Mahopac Central School District  
Mahopac, New York

Reconstruction at  
Mahopac High School  
Mahopac Middle School  
Mahopac Falls School  
Bus Garage  
New Pump House

Tt Project No. 121111-19002

### BID Addendum No. 4 to Drawings and Project Manual

**Subsurface Drainage System**  
N.T.S.

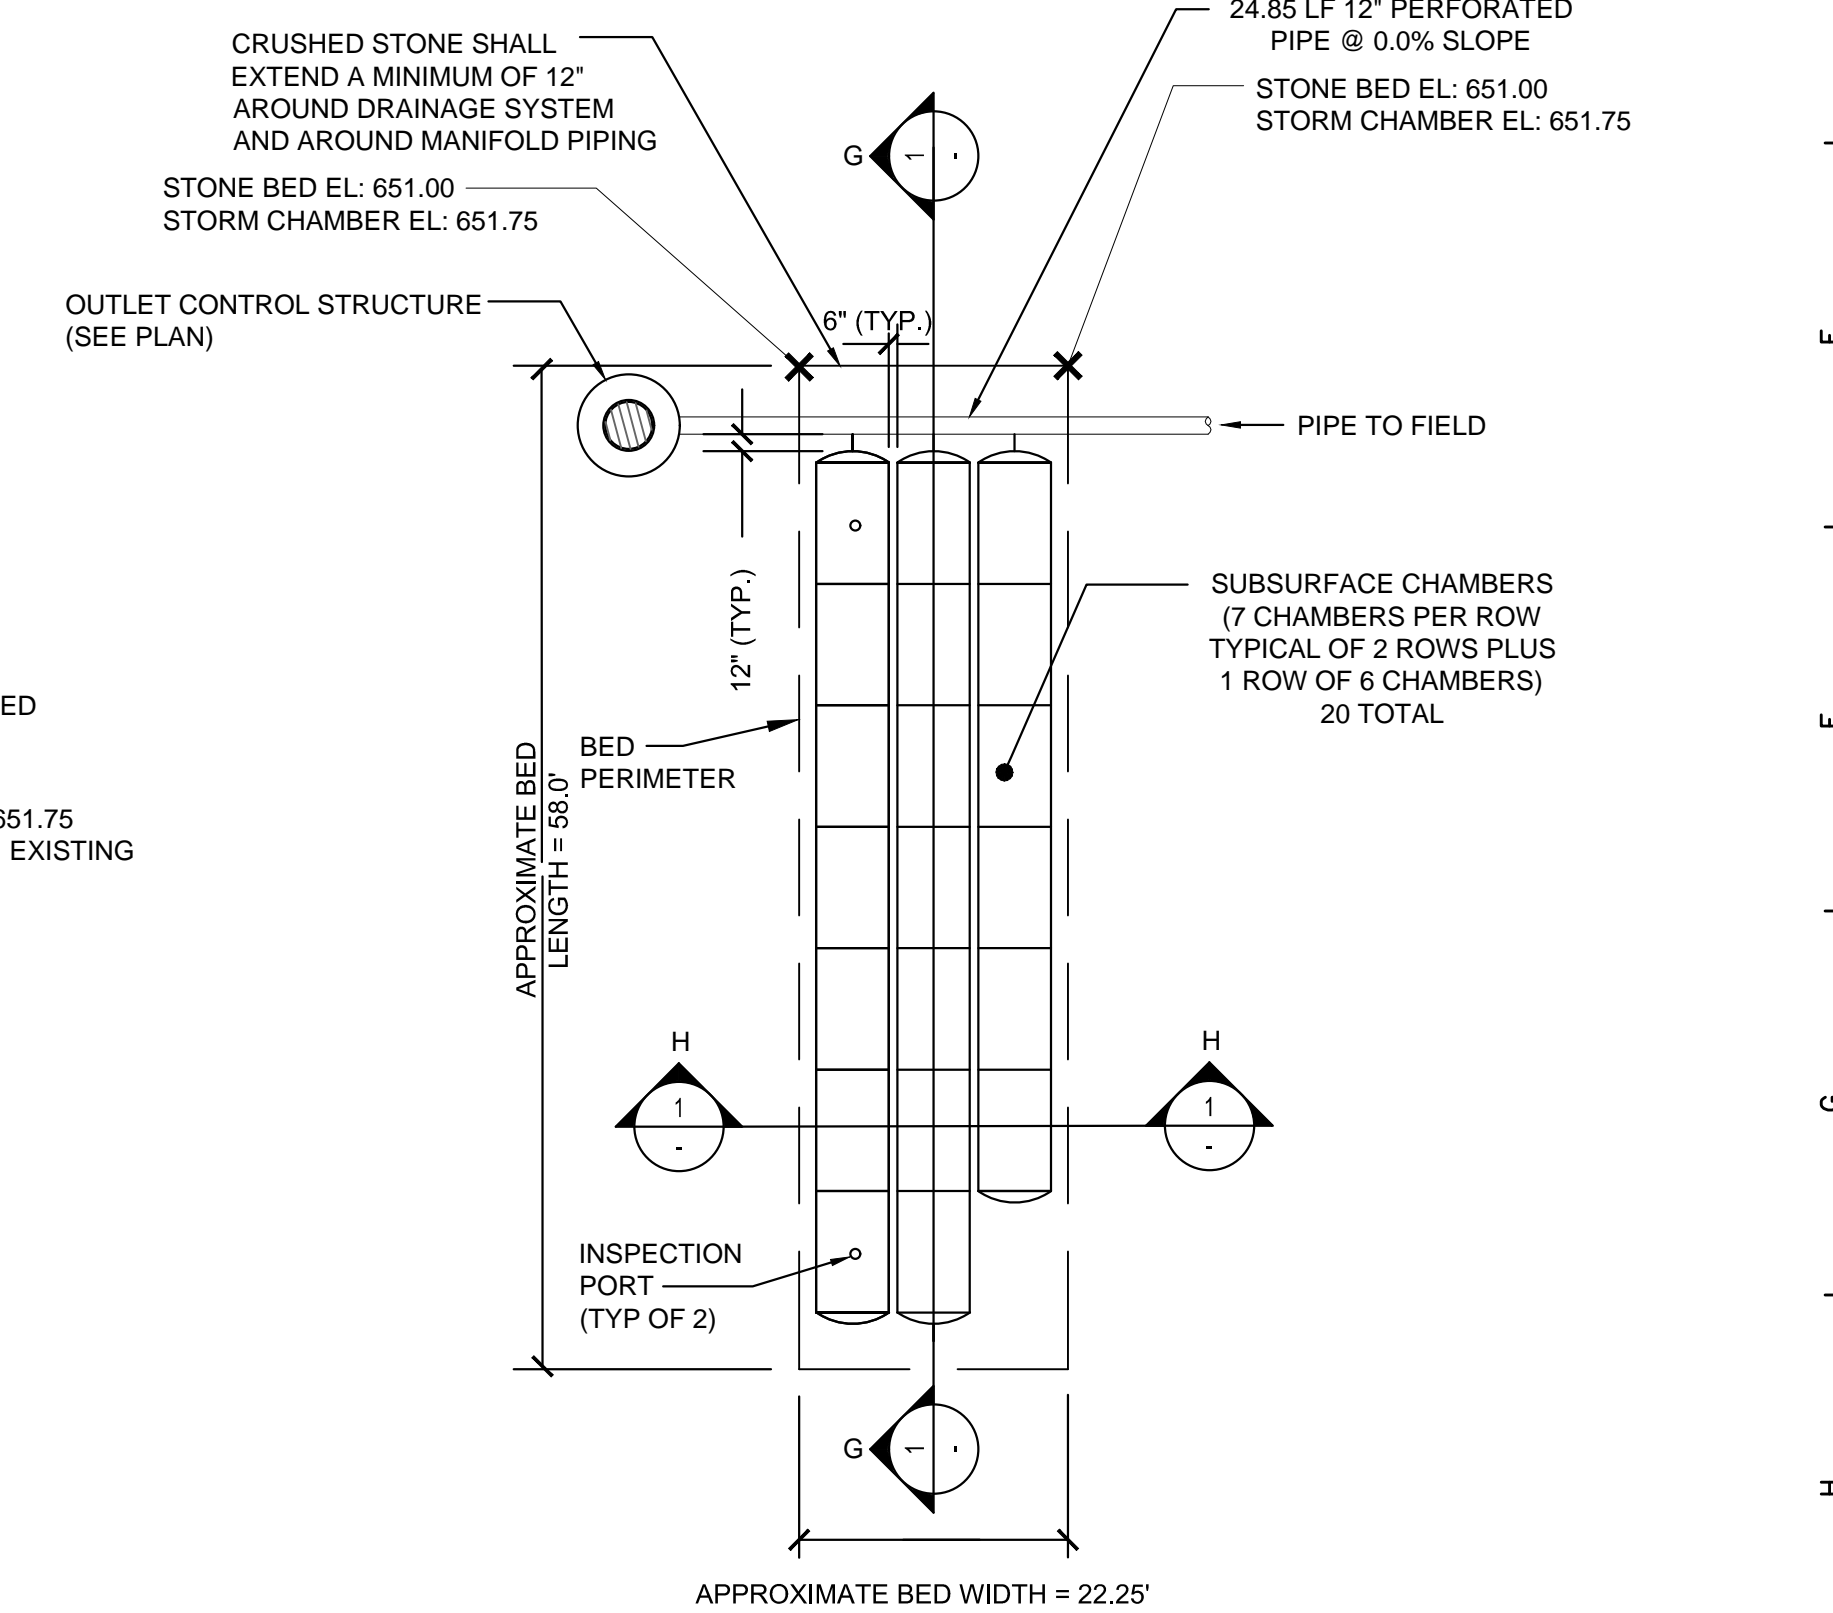
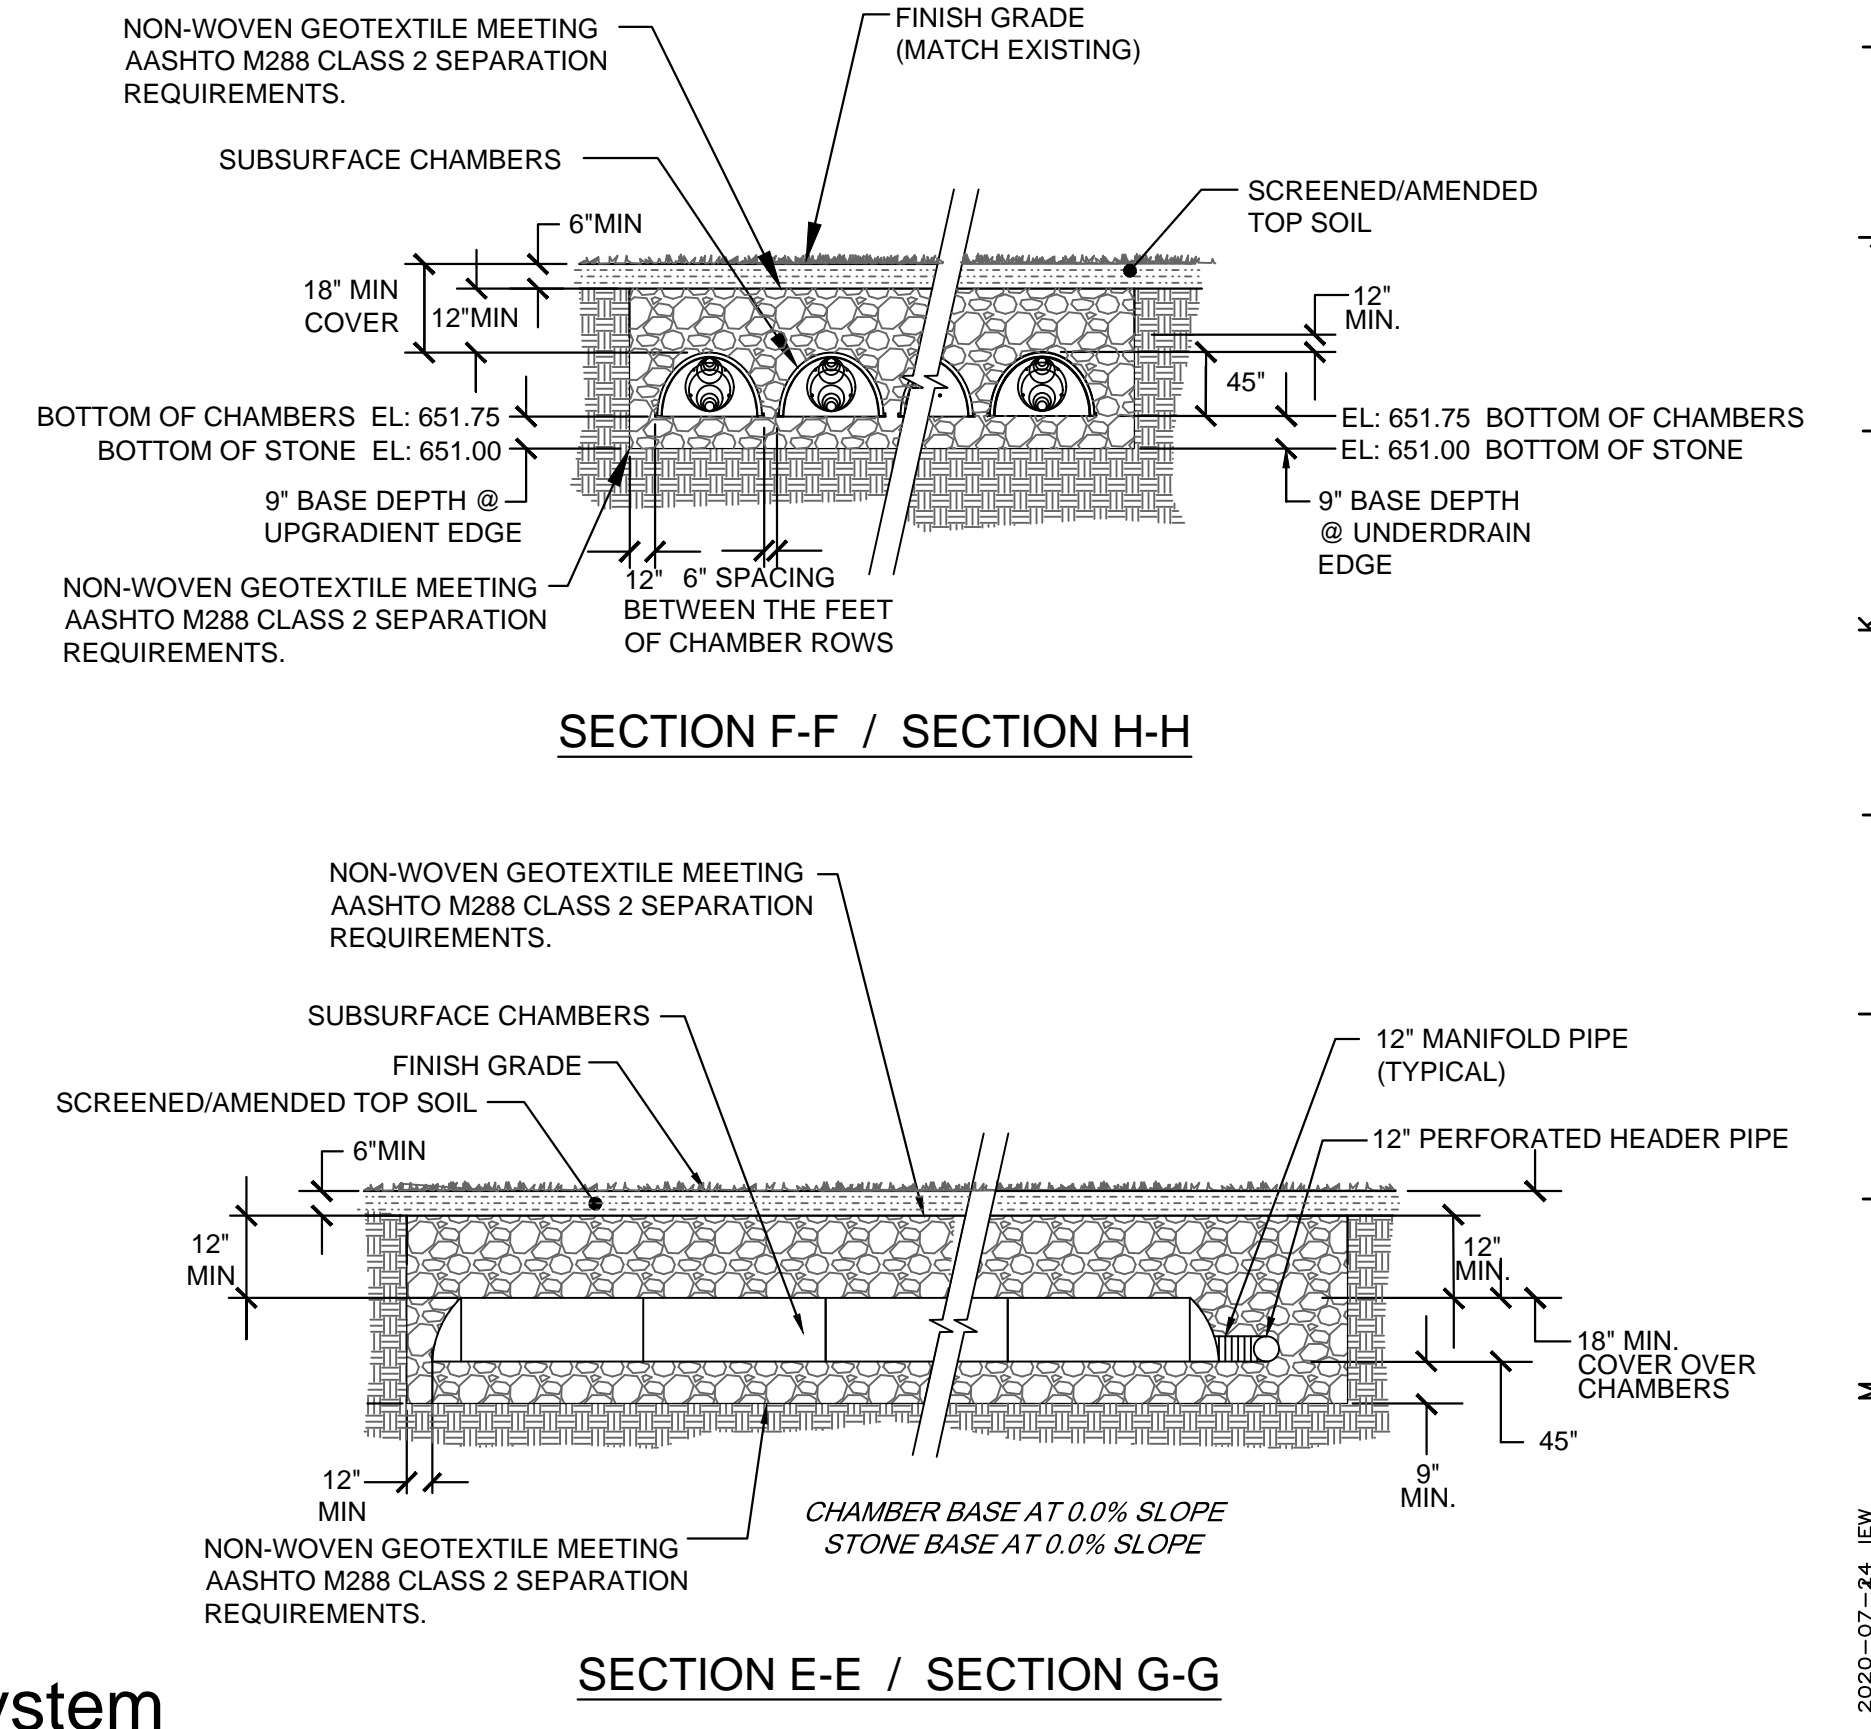
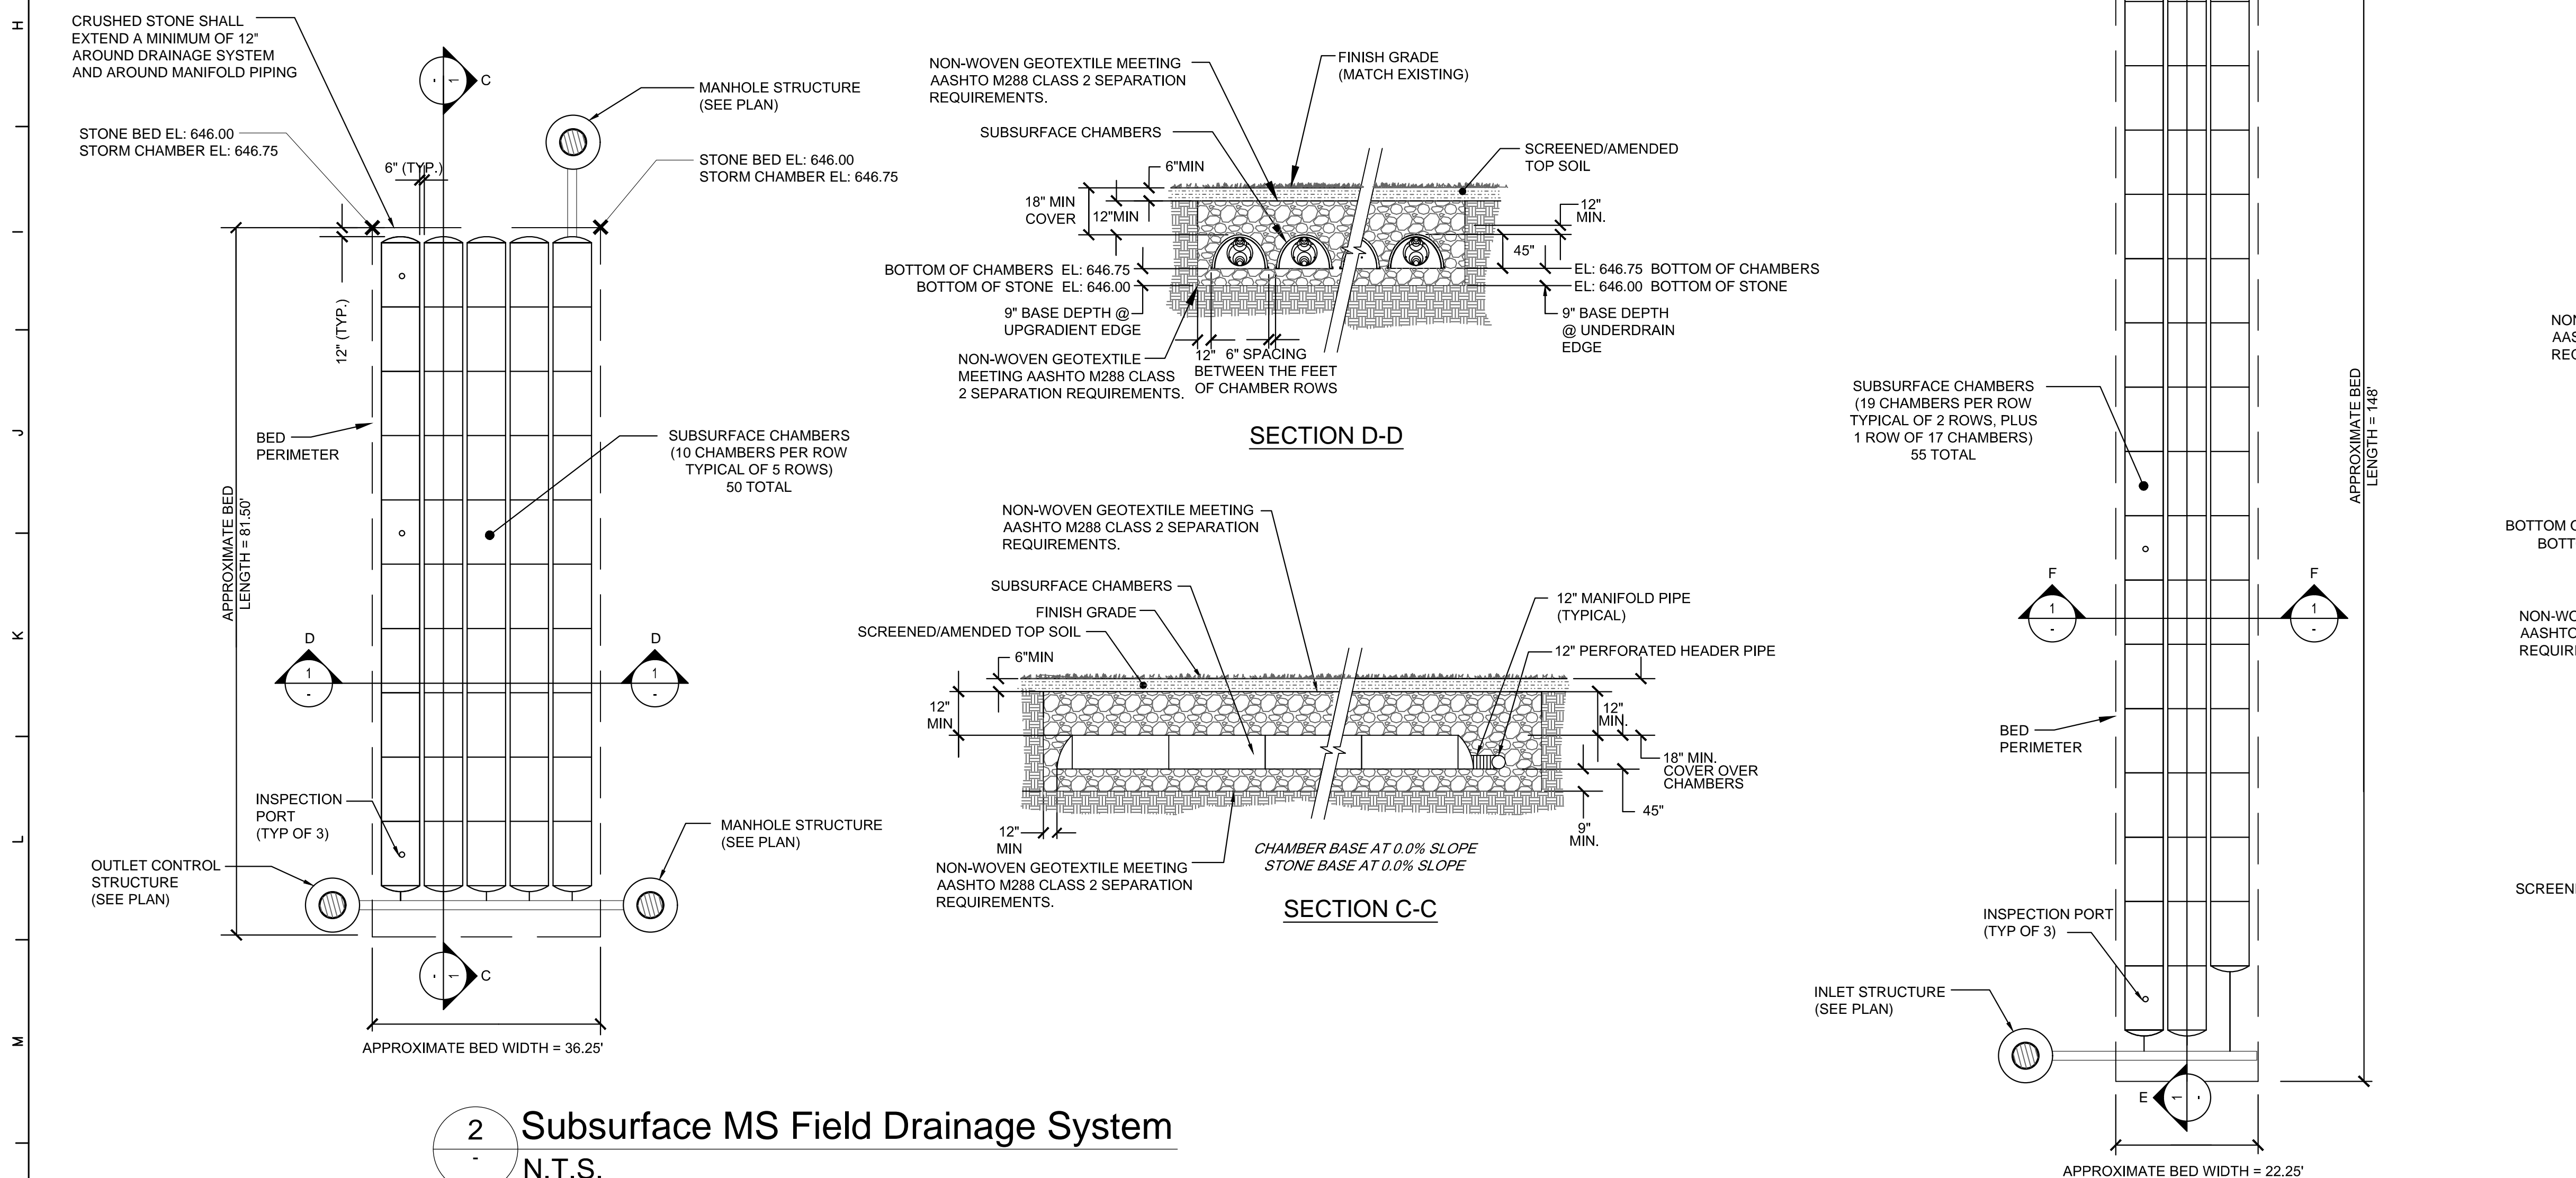
DETAIL 4 ON SHEET CZ-505 SHOWS THE CHAMBER SYSTEMS TO BE A HEIGHT OF 45". WHEN REFERRING TO THE SPEC SECTION, IT SPECIFIES THE CHAMBER TO BE A SC-740 BY STORM TECH. THIS MODEL IS ONLY 30" IN HEIGHT. PLEASE CLARIFY AS TO THE HEIGHT OF THE CHAMBER SYSTEM.

DRAWING # AC-140 SHOWS THE DRAINAGE CHAMBER SYSTEMS ON WEST SIDE.  
IT SCALES (1" = 30' ) TO BE APPROX. 155 LF LONG TO INCLUDE TIE IN PIPES.  
DETAIL SECTION ON CZ-505 STATES THE BASE LENGTH TO BE 110.22 LF  
THE SAME WITH THE EASTERN DRAINAGE CHAMBER SYSTEM. THE SCALE DOESN'T MATCH  
THE DETAIL SHOWN LENGTH. PLEASE CLARIFY ON WHICH DIMENSION TO USE FOR BIDDING.

Refer to forthcoming Addendum #4. Storm chamber systems indicated on revised and reissued Site Detail Drawing ZC505 shall apply.
